SUMMARY OF AA-1 SERVICE LETTERS

SERVICE

L
E
T
T
E
R

Figure 1. Defroster Outlet Sleeve Installation.

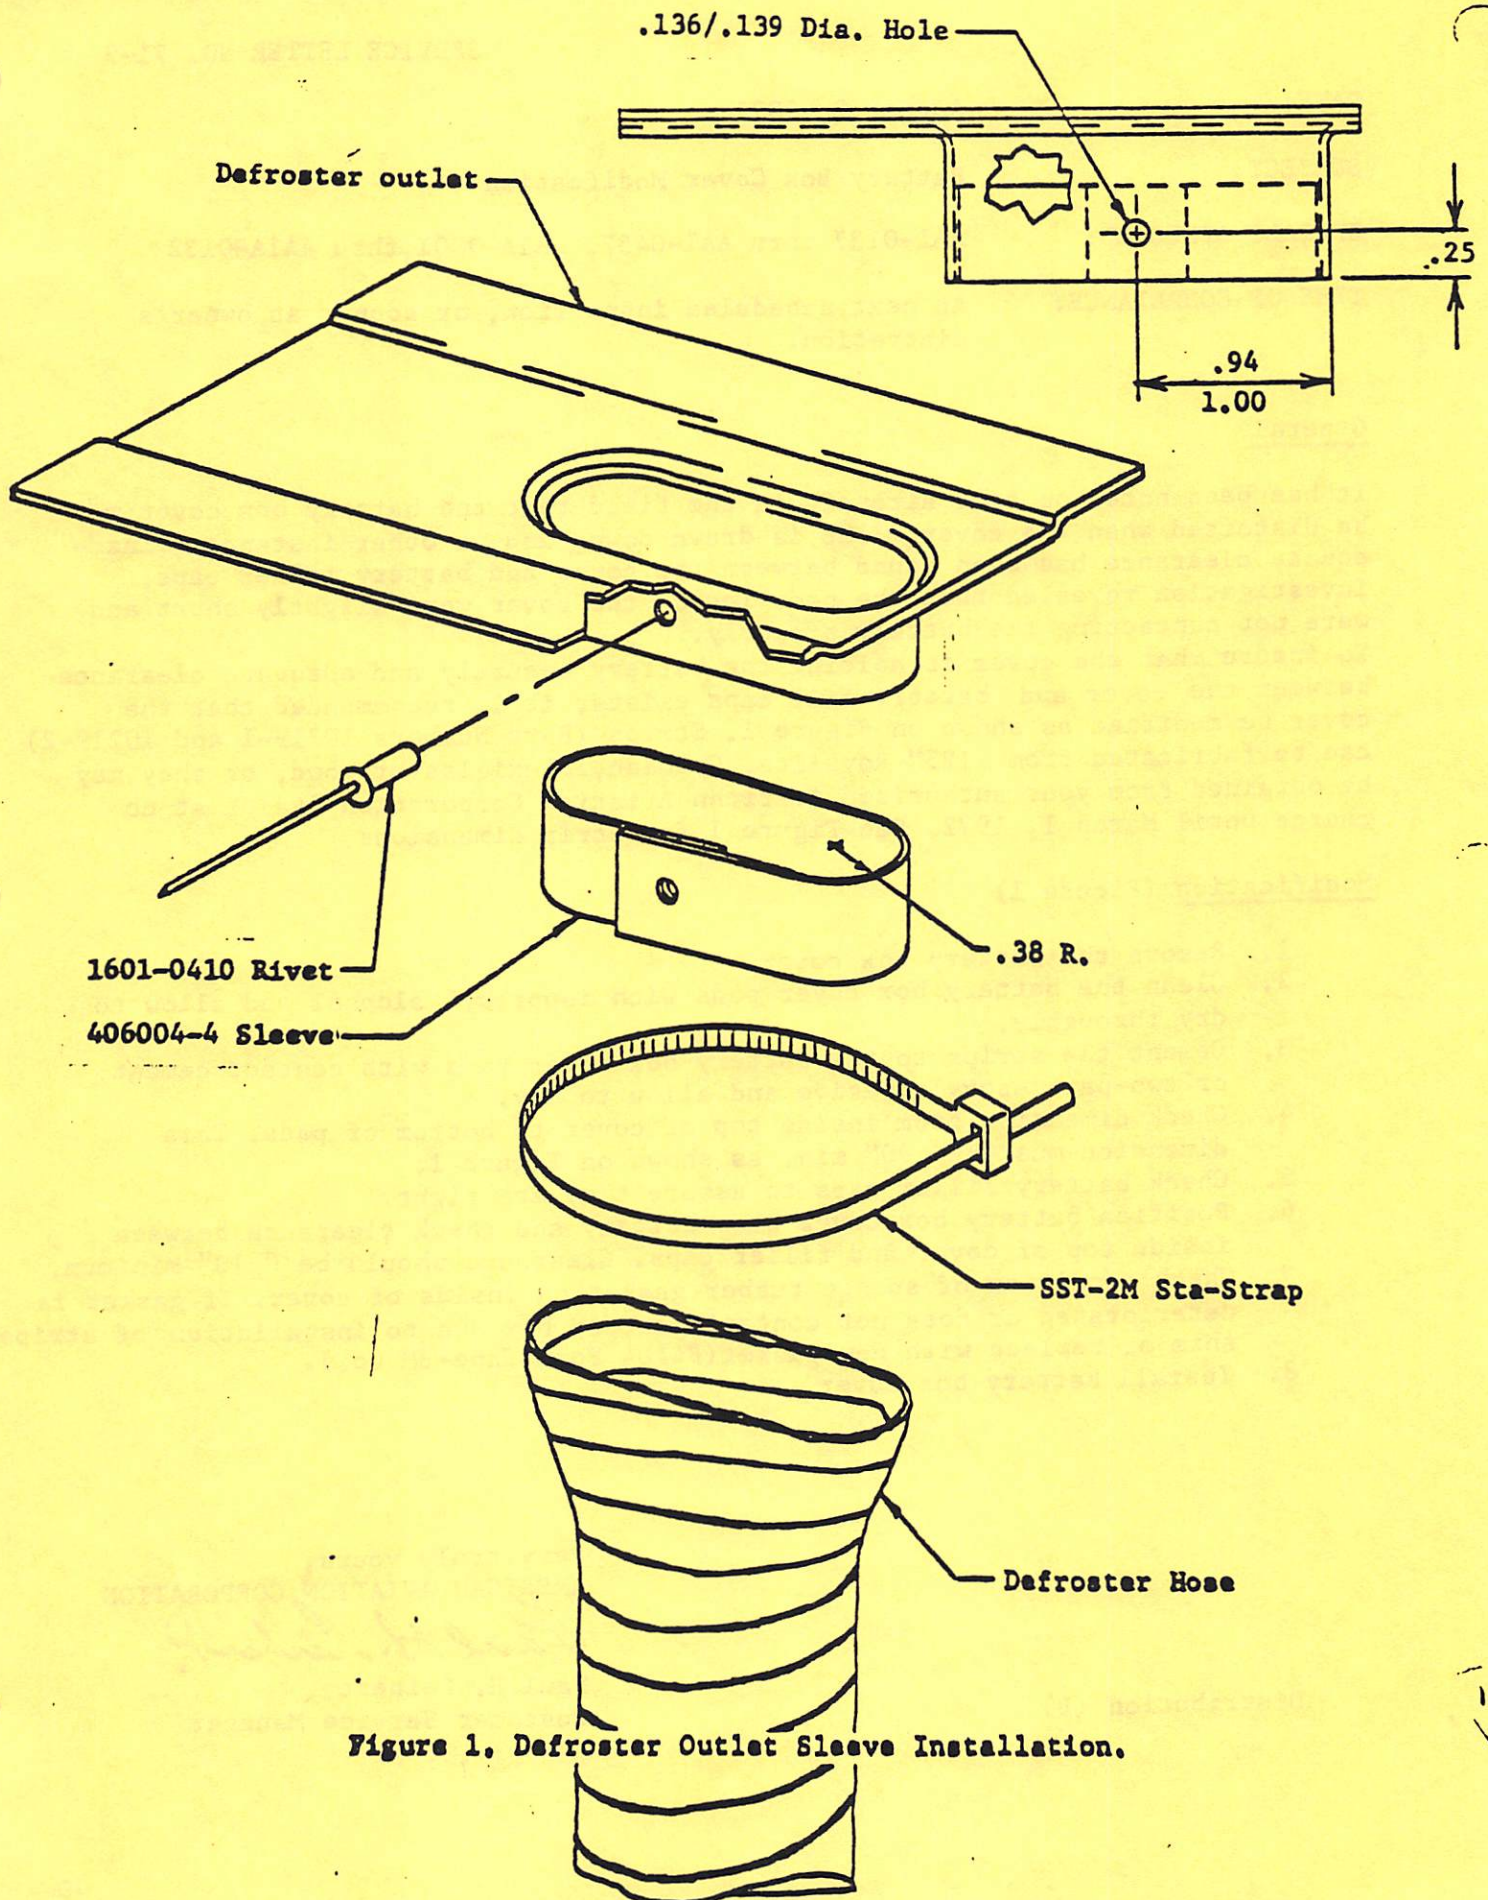
On some aircraft it has been noted that the defroster outlet duct has distorted allowing the defroster hose to become disconnected. A modification has been incorporated on current production aircraft, consisting of an aluminum sleeve riveted in place to prevent distortion of the duct. Parts are available for field installation if required (See figure 1).

Remove the deck from the aircraft. Install the 406004-4 sleeve into the outlet and drill a .136/.139 diameter hole through the outlet and sleeve as shown in Figure 1. Install rivet (1601-0410) using pop rivet tool (United Shoe Machinery, Part No. PRG410 or equivalent).

Figure 1. Battery Box Cover Modification

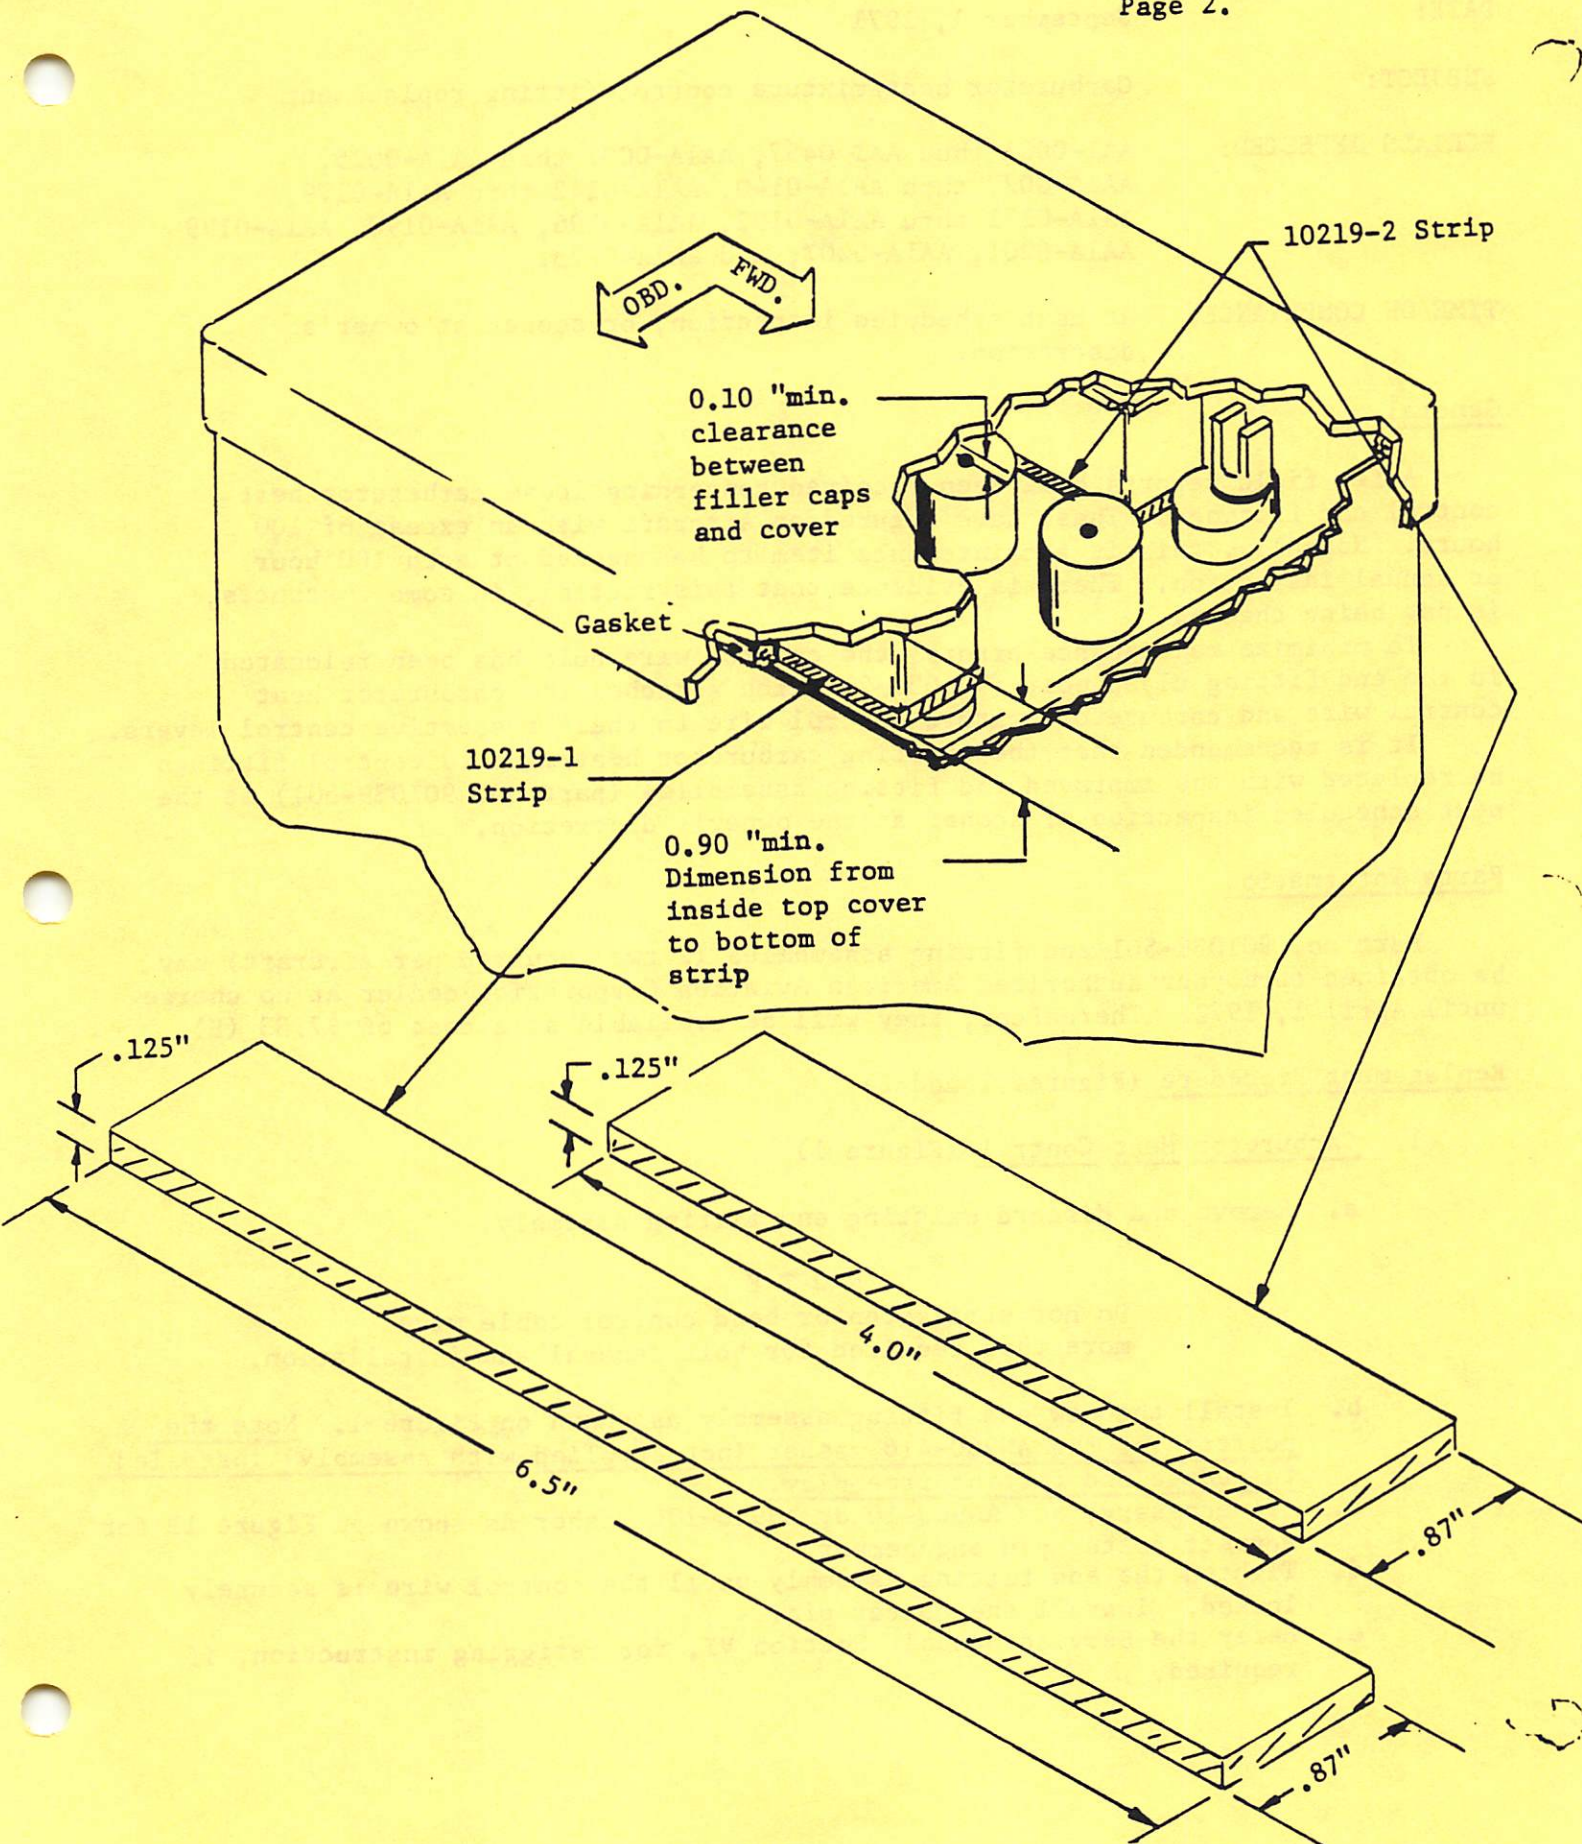
It has been noted on some aircraft in the field that the battery box cover may be distorted when the cover clamp is drawn down, and in other instances, inadequate clearance has been found between the cover and battery filler caps. Investigation revealed that the pads inside the cover were slightly short and were not contacting the battery properly. To insure that the cover is holding the battery securely and adequate clearance between the cover and battery fill caps exists, it is recommended that the cover be modified as shown on Figure 1. Strips (Part Numbers 10219-1 and 10219-2) can be fabricated from .125" Royalite, Cycolac, Plexiglas or wood, or they may be obtained from your authorized American Aviation Corporation Dealer at no charge until March 1, 1972. See Figure 1 for strip dimensions.

1. Remove the battery box cover.
2. Clean the battery box cover pads with isopropyl alcohol and allow to dry thoroughly.
3. Cement the strips to the battery box cover pads with contact cement or two-part epoxy adhesive and allow to dry.
4. Check dimension from inside top of cover to bottom of pads. This dimension must be .90" min. as shown on Figure 1.
5. Check battery filler caps to assure they are tight.
6. Position battery box cover over battery and check clearance between inside top of cover and filler caps. Clearance should be 0.10" minimum.
7. Check condition of sponge rubber gasket on inside of cover. If gasket is deteriorated or does not contact battery box due to installation of strips, shim or replace with new gasket (#4104 Foam Tape-3M Co.).
8. Install battery box cover.

1. Carburetor Heat Control (Figure 1)

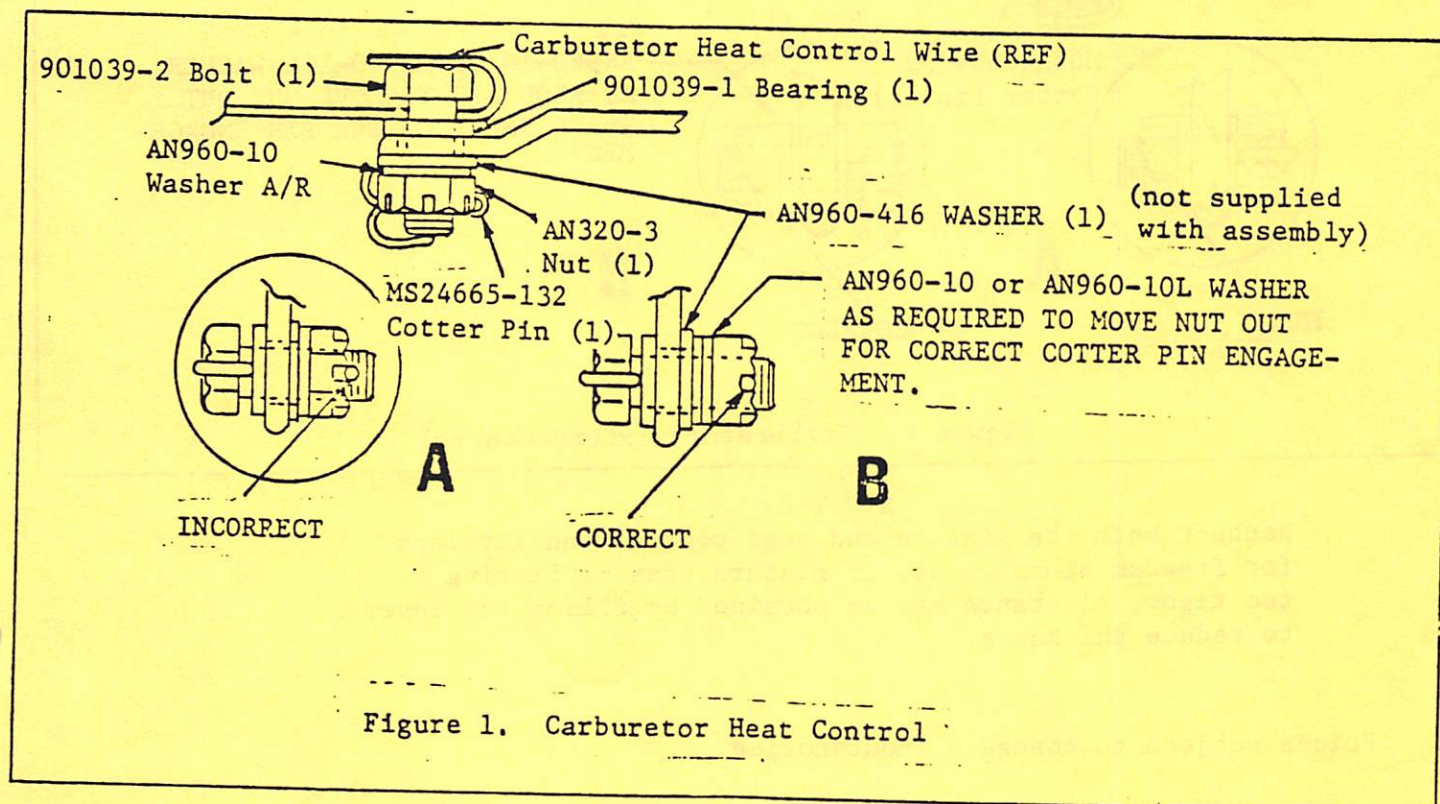
- b. Install the new end fitting assembly as shown on Figure 1. Note the position of the AN960-416 washer (not supplied with assembly) installed to reduce end fitting free play.
- c. If necessary, add AN960-10 or AN960-10L washer as shown on Figure 1B for correct cotter pin engagement.
- d. Tighten the end fitting assembly until the control wire is securely locked. Install the cotter pin.
- e. Refer the Service Manual, Section VI, for rerigging instruction, if required.

2. Carburetor Mixture Control (Figure 2)

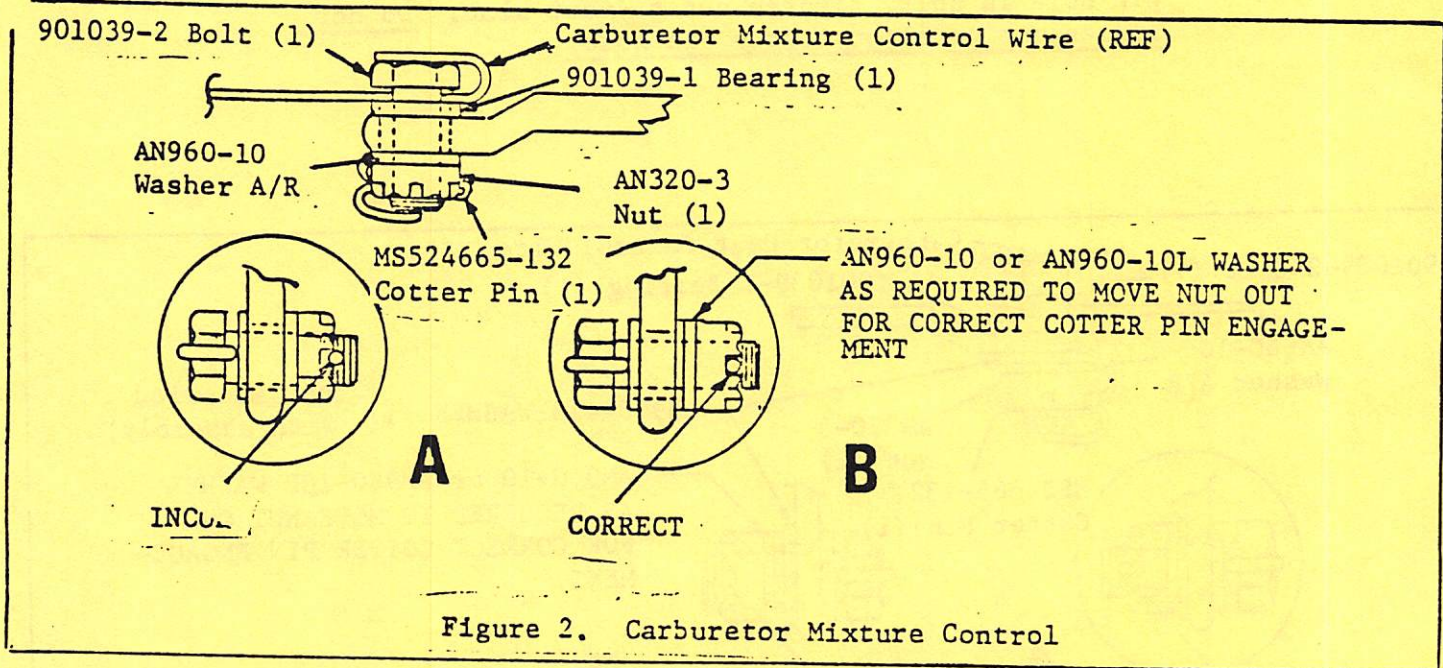
- a. Installation of the carburetor mixture control end fitting assembly is accomplished in the same manner as the heat control end fitting assembly with exception of the AN960-416 washer is not required. (See Figure 2 for proper location of parts and correct cotter pin engagement.)
- b. Refer to Service Manual, Section VI for rerigging instruction, if required.

Figure 4.

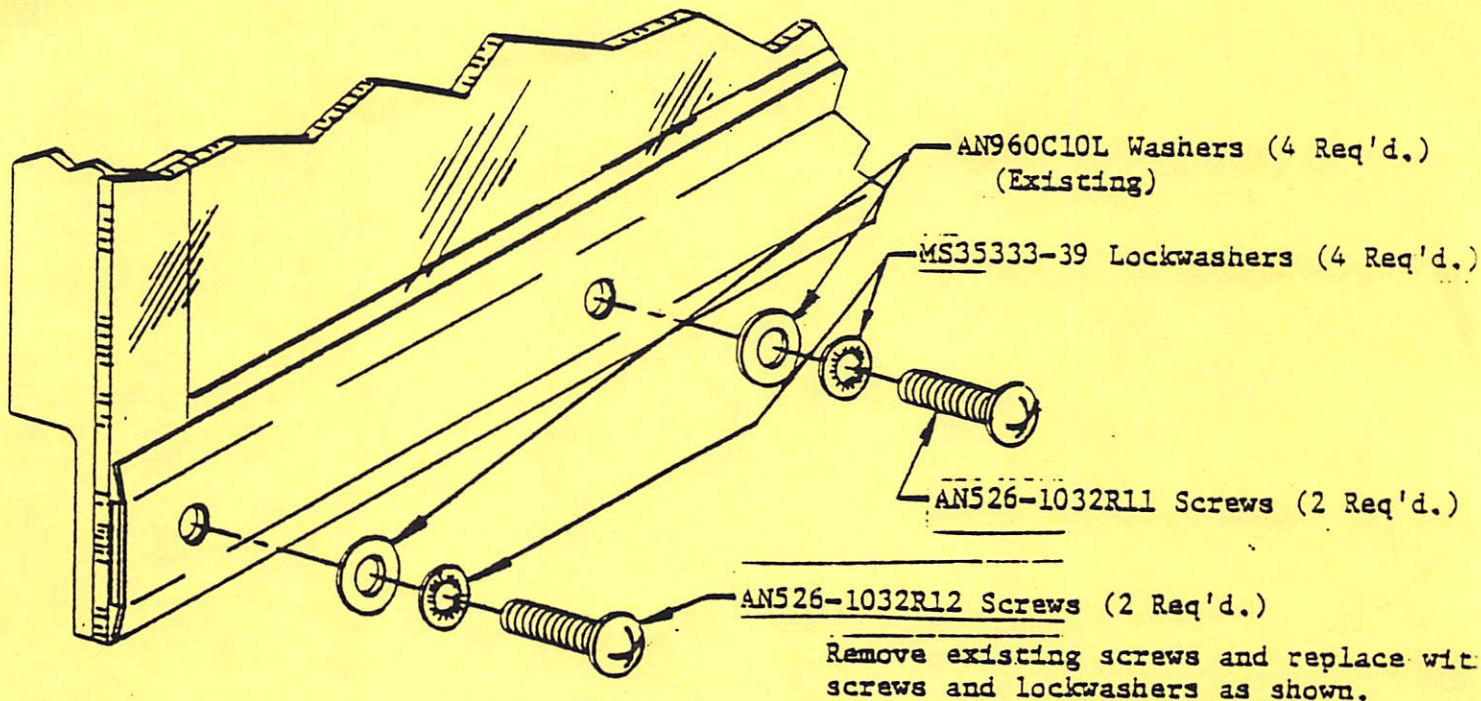
To prevent possible cracking of the canopy as a result of the Loctited screws loosening in service, it is recommended that the screws on the above affected aircraft be inspected for security within the next 10 hours of operation. If the screws are found loose, they should be replaced with the improved hardware shown in Figure 4.

It is further recommended that the original hardware be replaced per Figure 4 regardless of condition, at the next interval of maintenance that requires canopy removal for cleaning and lubricating of the tracks.
